Interoffice Correspondence

RE: Application for Draft Plan Approval Extension – Dalron Construction Ltd. – PIN 73578-0515, Part 1, Plan 53R-18272, Part of Lots 11 & 12, Concession 3, Township of Neelon (Greenwood Subdivision, Sudbury)

LAKEVIEW SUBDIVISION
PHASE V
GREENWOOD DRIVE
EXTENSION OF ROADWAY
 TOWNSHIP OF NEELON

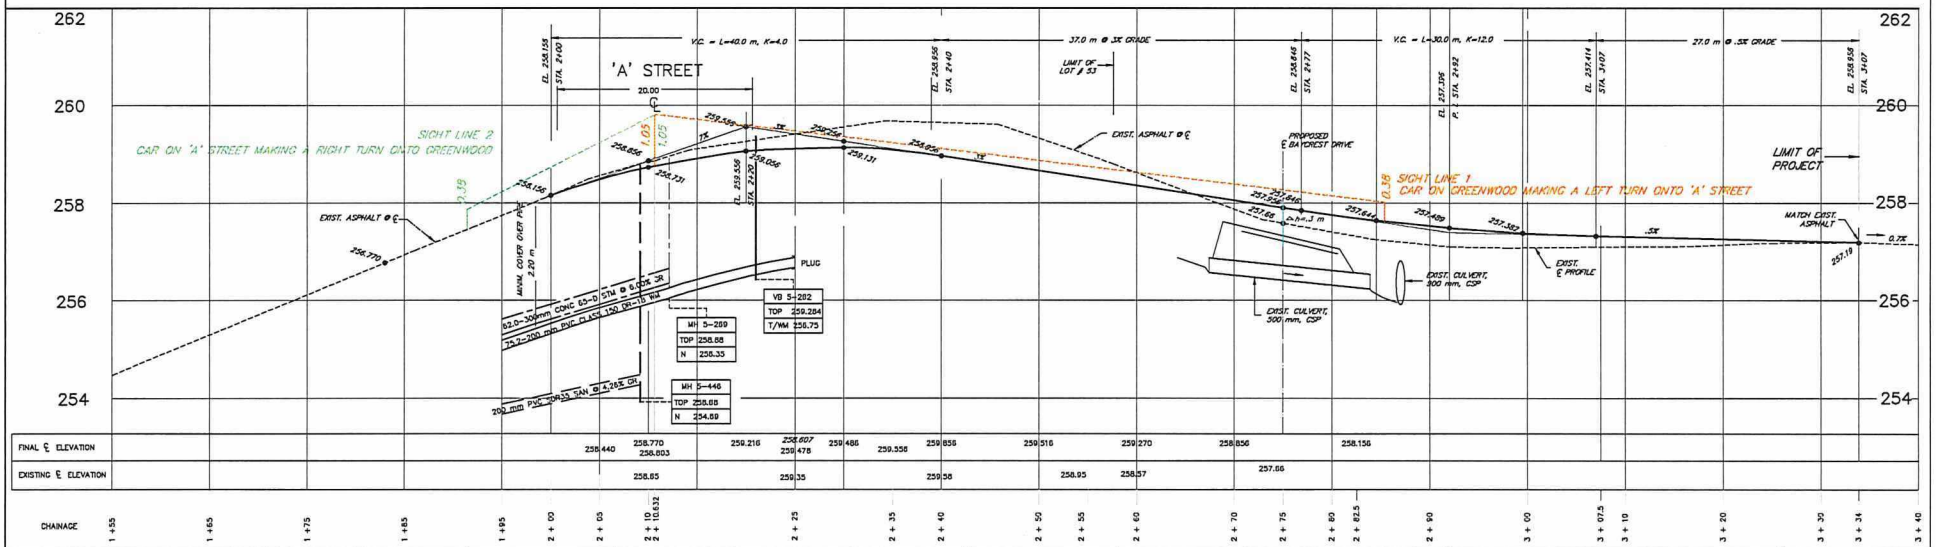
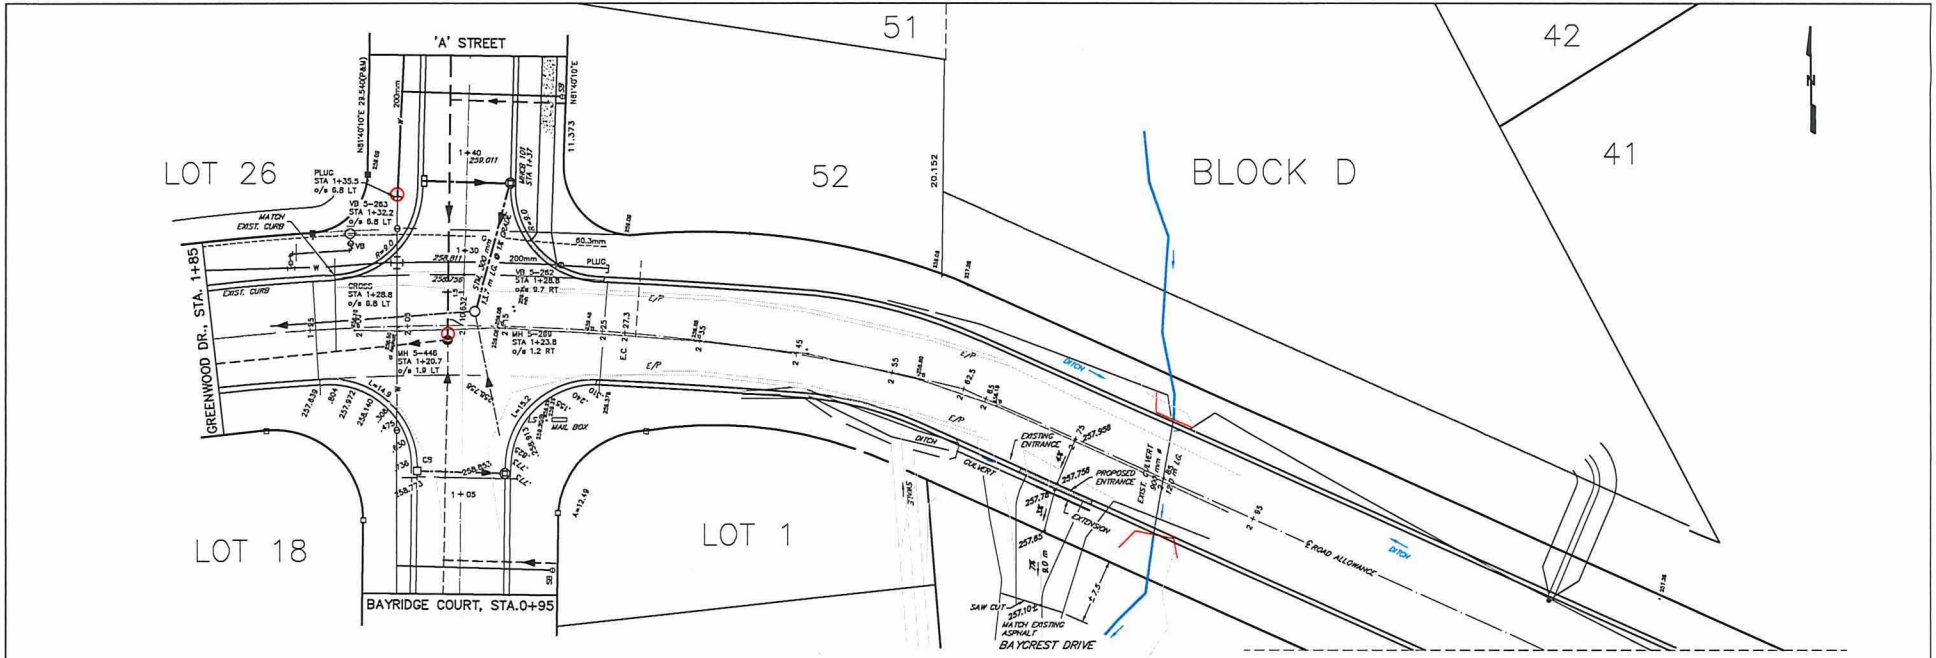
As a result, staff is now recommending by way of this memorandum that Condition #25 in the draft approval document be deleted entirely and replaced with the following:

"25. That the vertical alignment of Greenwood Drive at the north intersection of Street "A" be improved to satisfy a design speed of 60 km/hr and be in substantial accordance with the design concept plan prepared by S.A. Kirchhefer Ltd. and dated July 5, 2021 and to the satisfaction of the General Manager of Growth and Infrastructure."
